ADDRESS: 1416 DIAMOND ST

Proposal: Demolish front façade, the only remaining portion of the building

Review Requested: Final Approval

STAFF RECOMMENDATION: Denial, pursuant to Section 14-1005(6)(d).

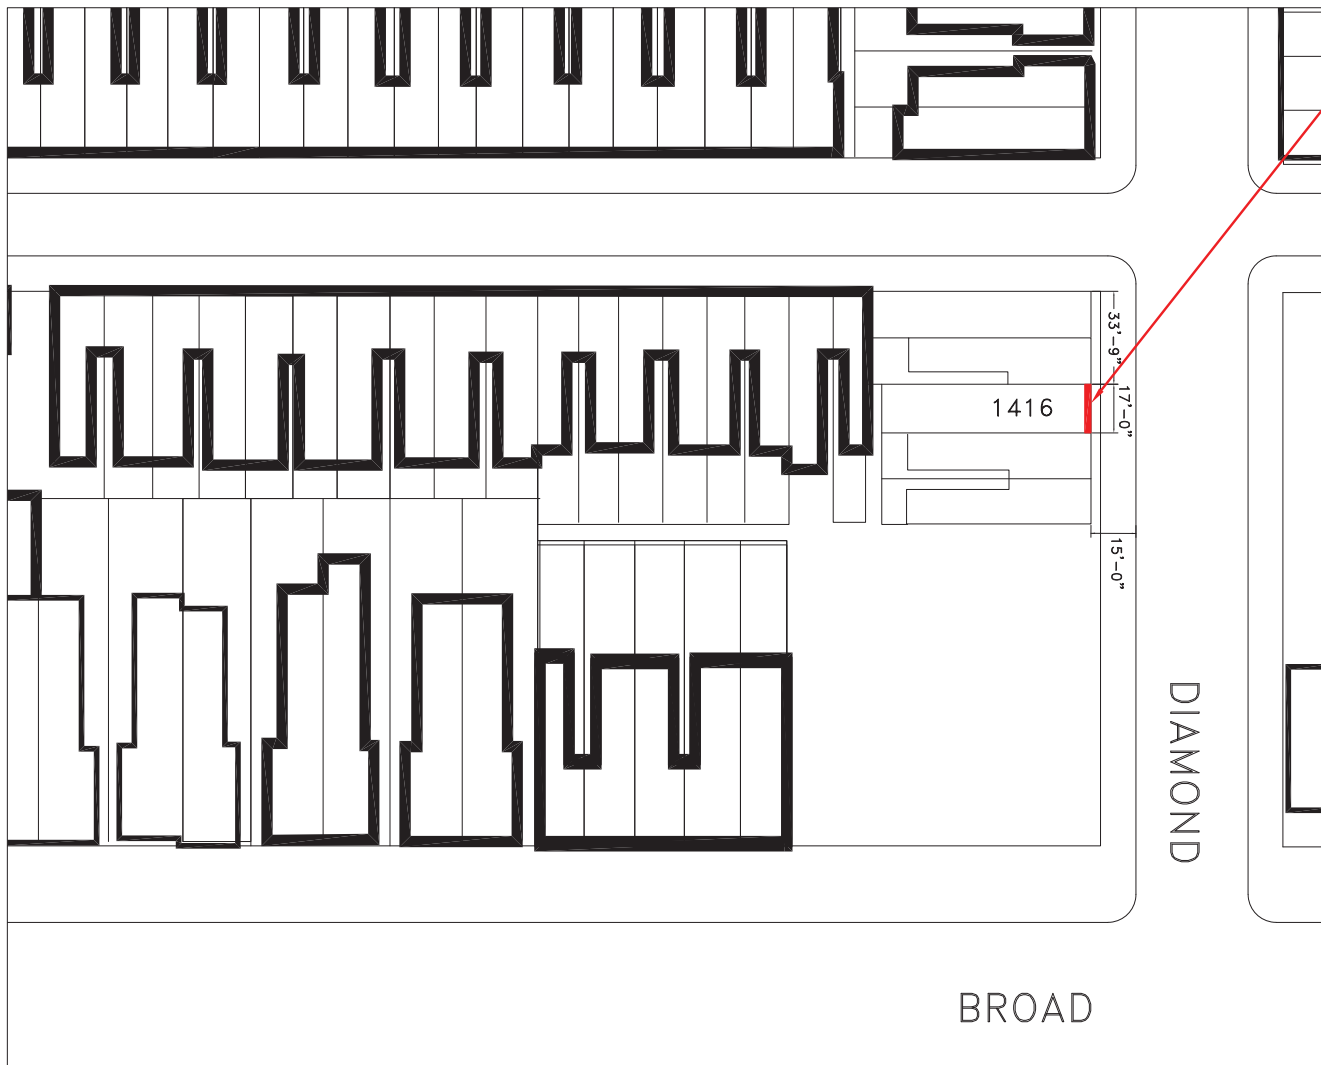
LOCATION: Entire

Free standing wall,brown stone de-laminating

EXTERIOR WALLS ARE NOT ANCHORED TO SUPPORTING AND/OR SUPPORTED ELEMENTS OR ARE NOT PLUMB AND FREE OF HOLES, CRACKS OR BREAKS AND LOOSE OR ROTTING MATERIALS, ARE NOT PROPERLY ANCHORED OR ARE NOT CAPABLE OF SUPPORTING ALL NOMINAL LOADS AND RESISTING ALL LOAD EFFECTS PM-304.1(7)

THE DEPARTMENT INSPECTED THE SUBJECT STRUCTURE AND DETERMINED IT IS IN IMMINENT DANGER OF COLLAPSE YOU MUST REPAIR OR DEMOLISH SAID STRUCTURE IMMEDIATELY. WHEN THERE IS IMMINENT DANGER OF FAILURE OR COLLAPSE OF A STRUCTURE OR ANY PART THEREOF WHICH ENDANGERS LIFE, OR WHEN ANY STRUCTURE OR PART OF A STRUCTURE HAS FALLEN AND LIFE IS ENDANGERED BY THE OCCUPATION OF THE STRUCTURE, THE CODE OFFICIAL IS AUTHORIZED AND EMPOWERED TO ORDER AND REQUIRE THE OCCUPANTS

Photo 1

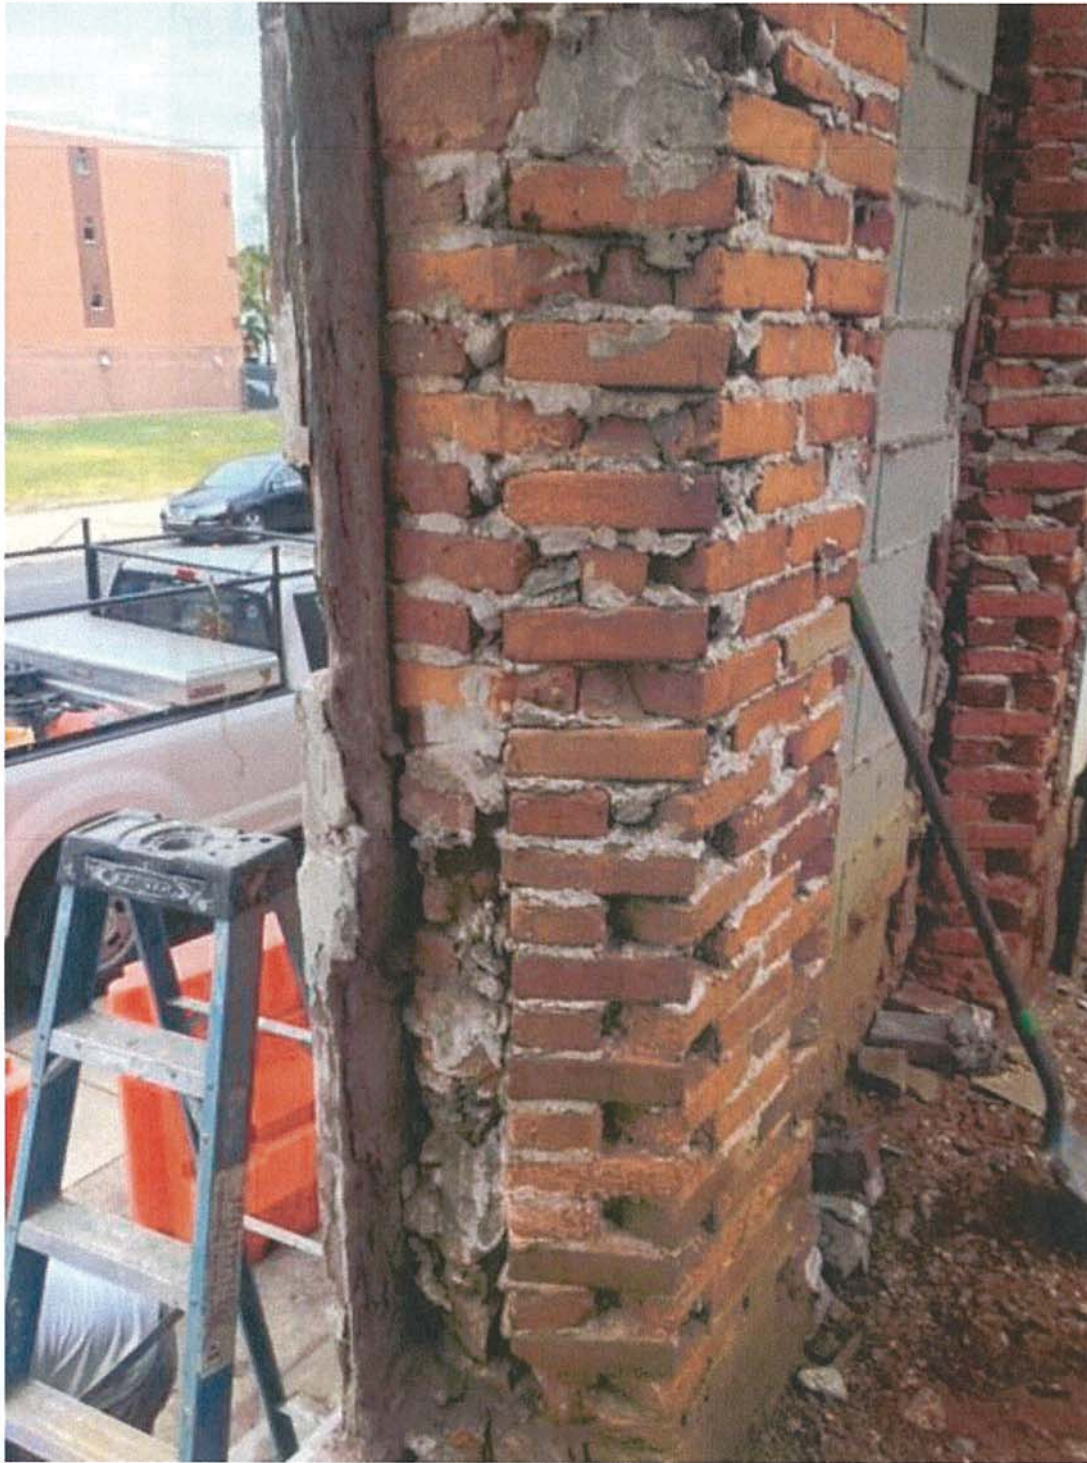
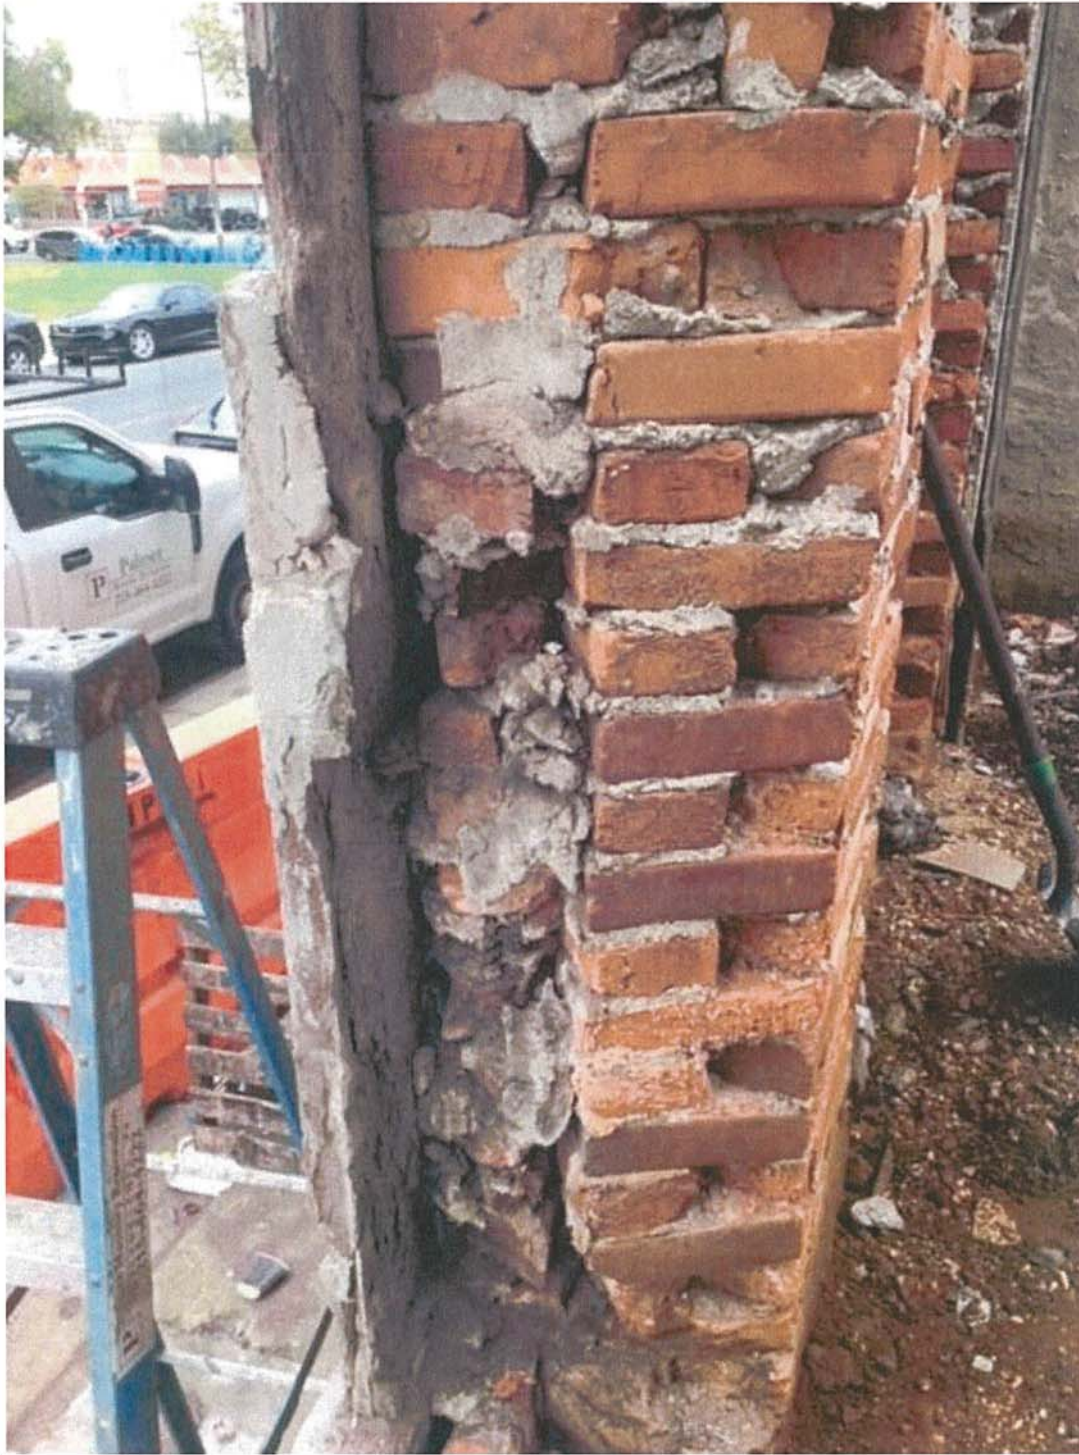
- We confirmed that the existing brick back-up wall is composed of three wythes of common brick. We observed indications of brick failure at exposed brick elements including section loss, erosion, cracks, and spalls. (Photos 1 – 3).

Photo 6

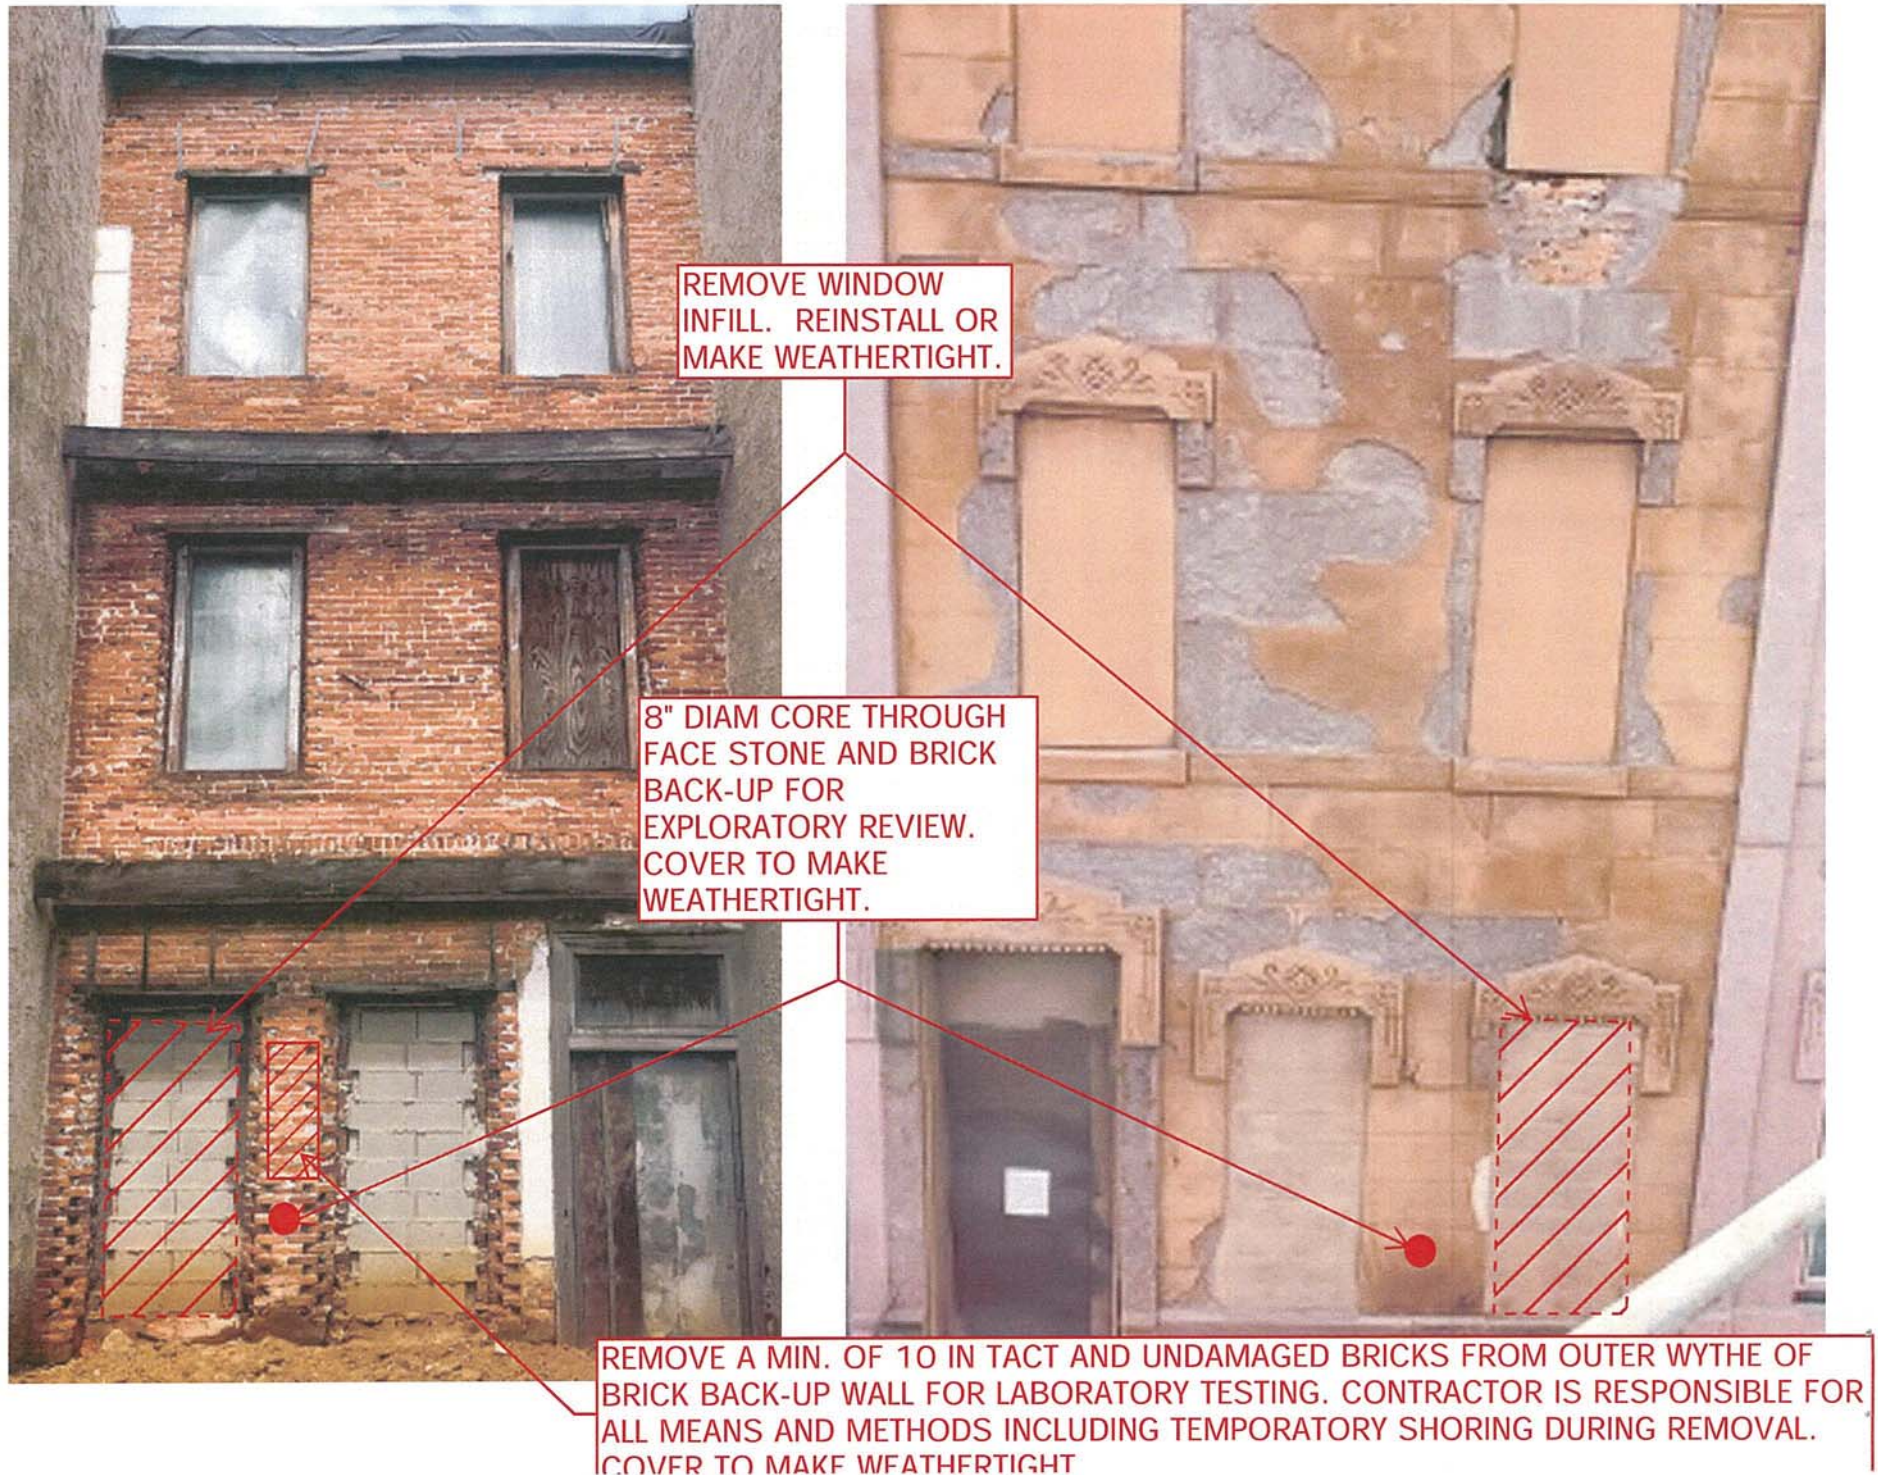
- Existing brownstone veneer is approximately 2" thick. The veneer panels showed evidence of previous repairs with a cementitious material applied to the exterior surface and coated with an unknown material (Photos 4 – 7).

- Parging and coating of existing brownstone may be contributing to the advanced deterioration of existing masonry material. Brownstone is a soft and porous sedimentary rock composed of feldspar, quartz, mica, and iron oxides. Weathering or erosion of brownstone surface are caused by several factors including water infiltration, residual moisture, acidic rain water, snow, temperature fluctuations (freeze/thaw cycles), wind exposure, and atmospheric pollutants. These factors may also contribute to small cracks or fissures in the stone allowing for water infiltration, promoting salt migration and corrosion of supporting elements. Brownstone was commonly installed with the bedding planes of the stone laid vertically, parallel to the façade, to ensure the color and texture was uniform. However, this installation method contributes to the higher frequency of deterioration in brownstone facades. As bedding planes begin to delaminate, the face-bedded brownstone flakes off in sheets leaving an uneven surface and section-loss in the façade (See Photos 6 and 7). Improper patching, parging, and coating of brownstone may create a vapor barrier; trapping residual moisture within the face of the stone and contributing to the deterioration of adjacent brick and brownstone.
